Supplementary Information

To: Central Coast Local Planning Panel
From: Robert Eyre- Principal Development Planner South
Ailsa Prendergast- Section Manager Development South
Andrew Roach- Unit Manger Development
Subject: Additional Information – Agenda item 3.1
Date: 7 April 2021

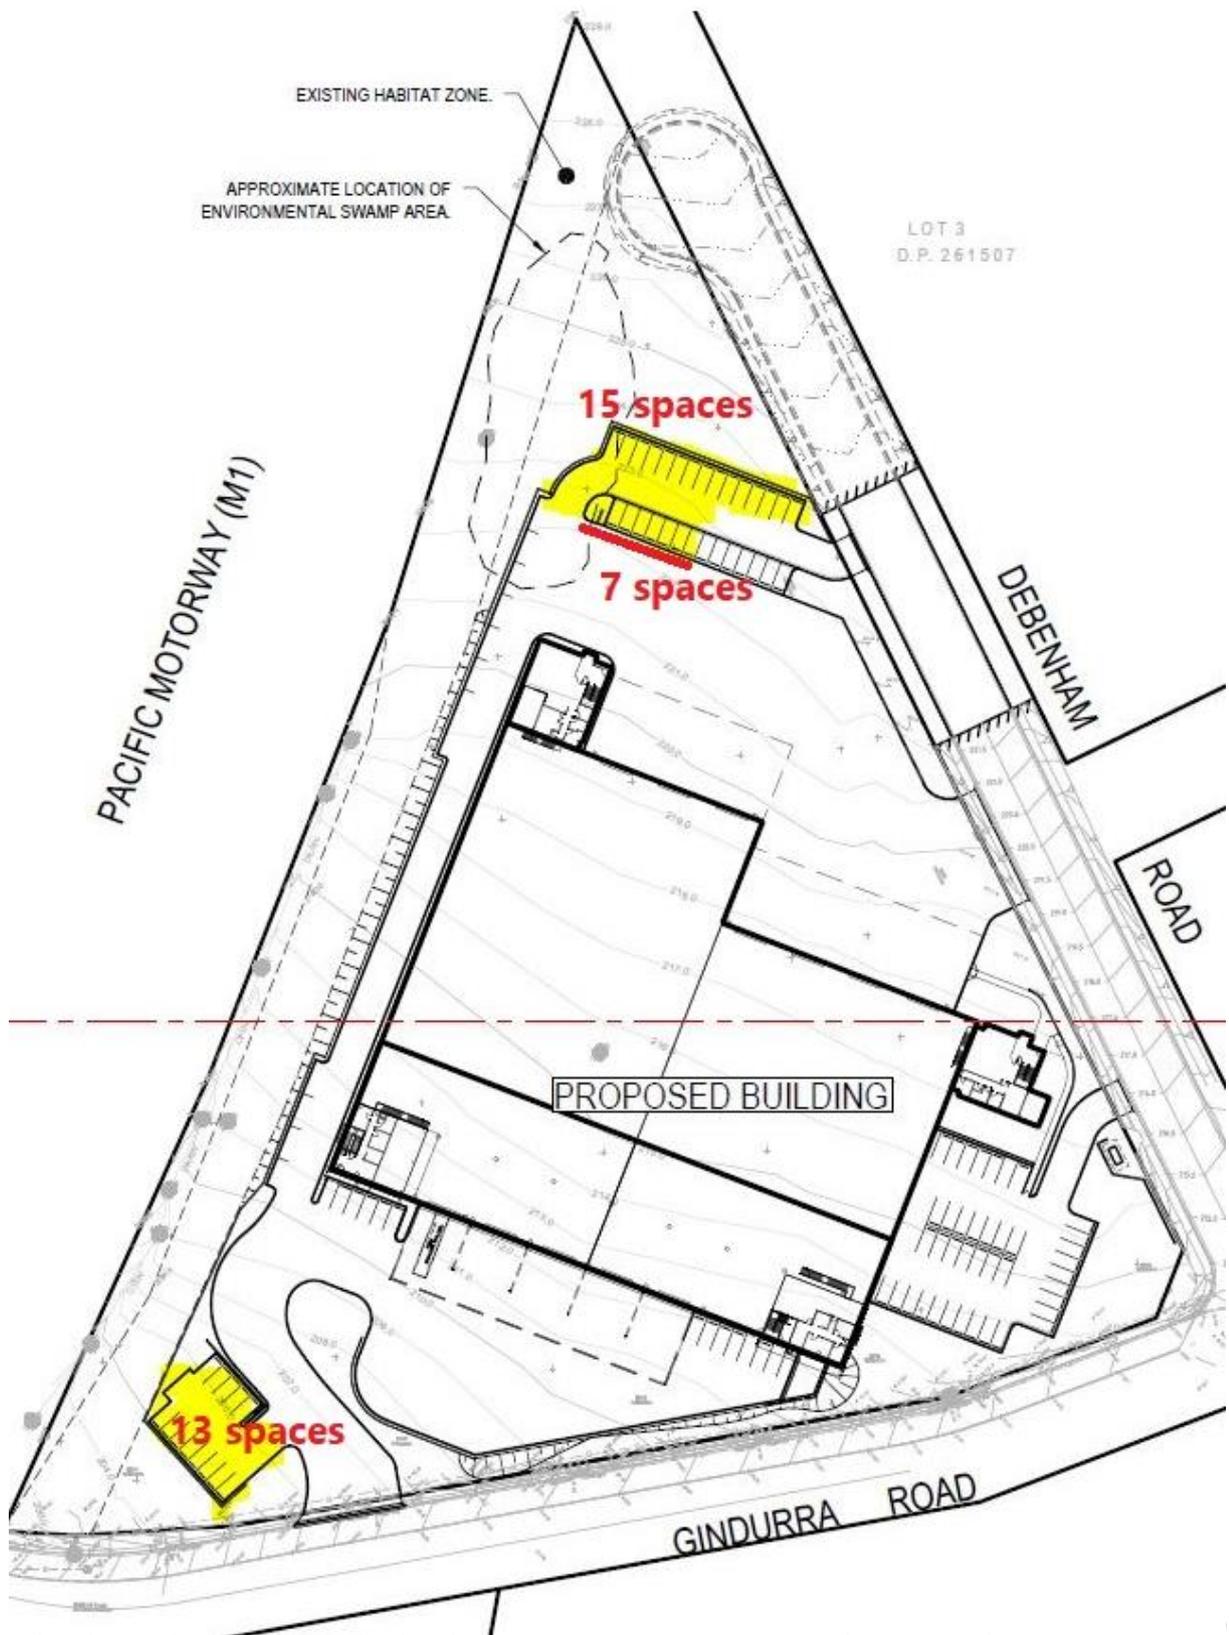
1. If the panel was minded to reduce parking by up to 35 spaces, which 35 parking space reduction would lead to the best biodiversity outcome?

Response- Council's ecologist has identified two locations where carparking could be reduced to improve biodiversity outcome.

1. South West Corner (13 spaces). This area contains vegetation in highest condition that includes key food resources plants of the Eastern Pygmy Possum. A temporary sediment basin located in this area would need to be relocated. Retention of vegetation in this area may also help facilitate greater habitat connectivity for the Eastern Pygmy Possum.
2. North West Corner (total of 22 spaces). This area contains Coastal Upland Swamp EEC. Retention of vegetation in this area may help facilitate greater habitat connectivity for the Eastern Pygmy Possum. **(Refer plan below).**

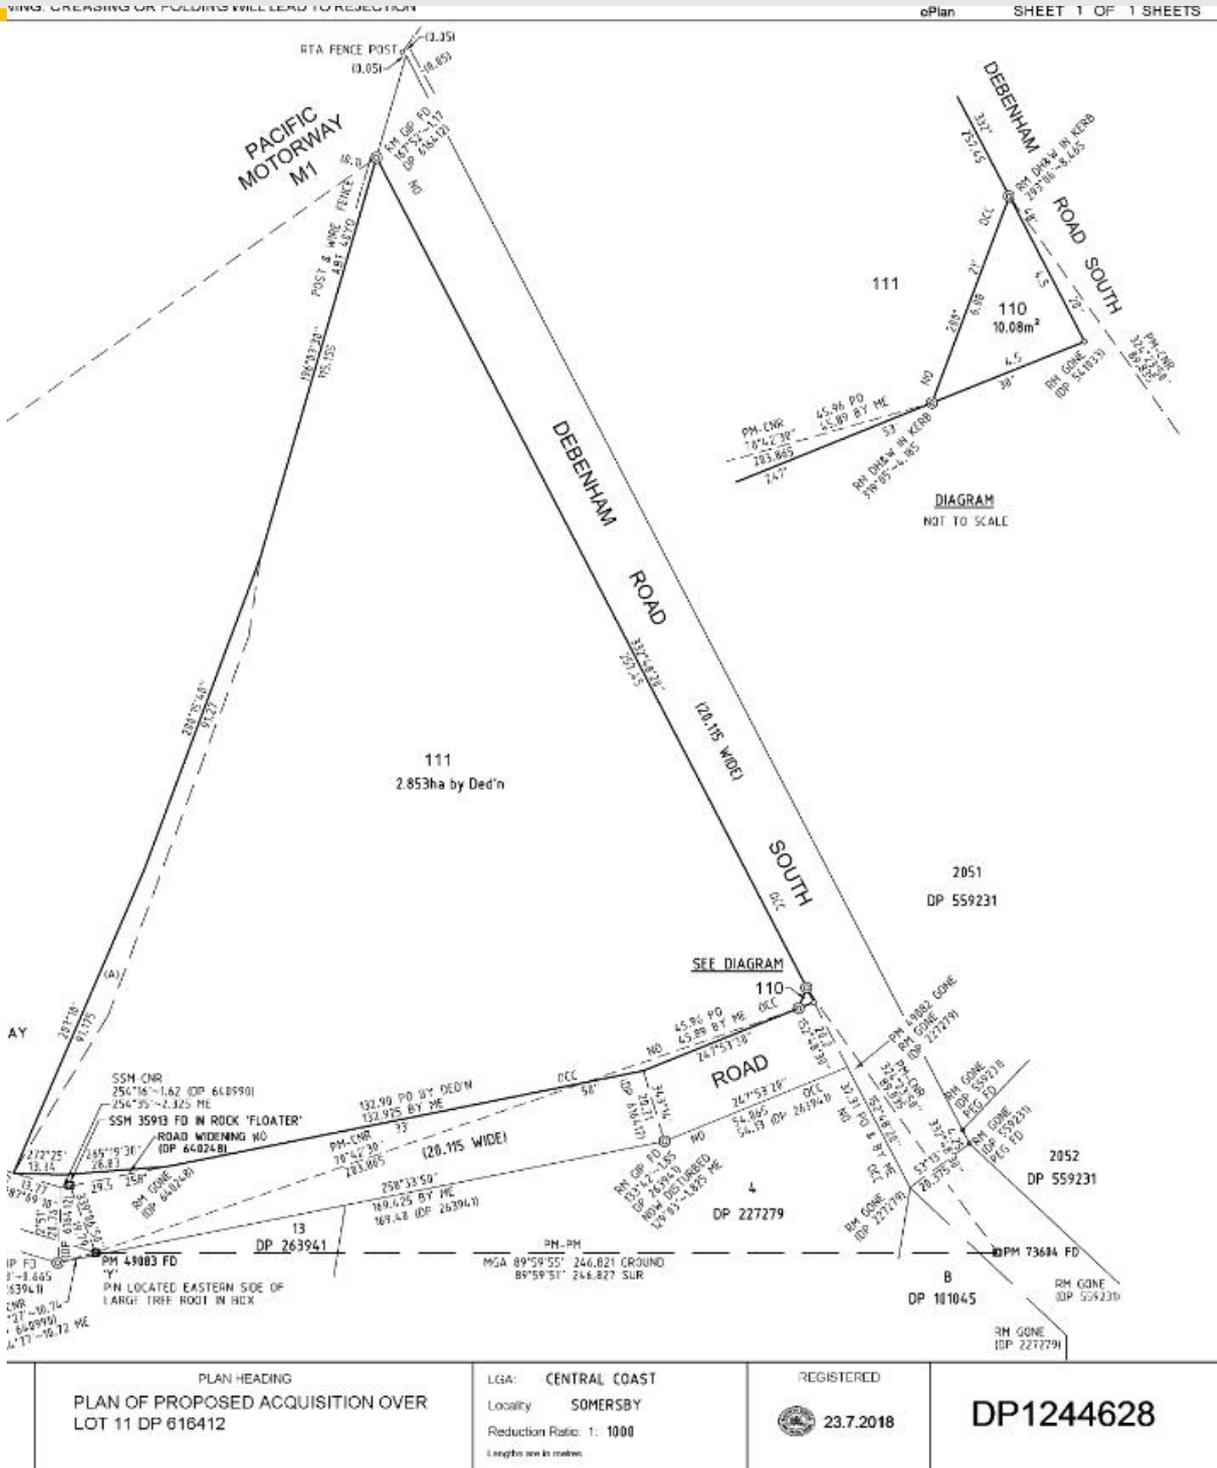
7. *Pg 36 cites road widening and ensuring plan shows this – please clarify*

Response- This involves the cut-off on the corner of Gindurra Road and Debenham Road. The survey plan has been prepared but not registered. The development proposal allows for the road widening. See below plan.
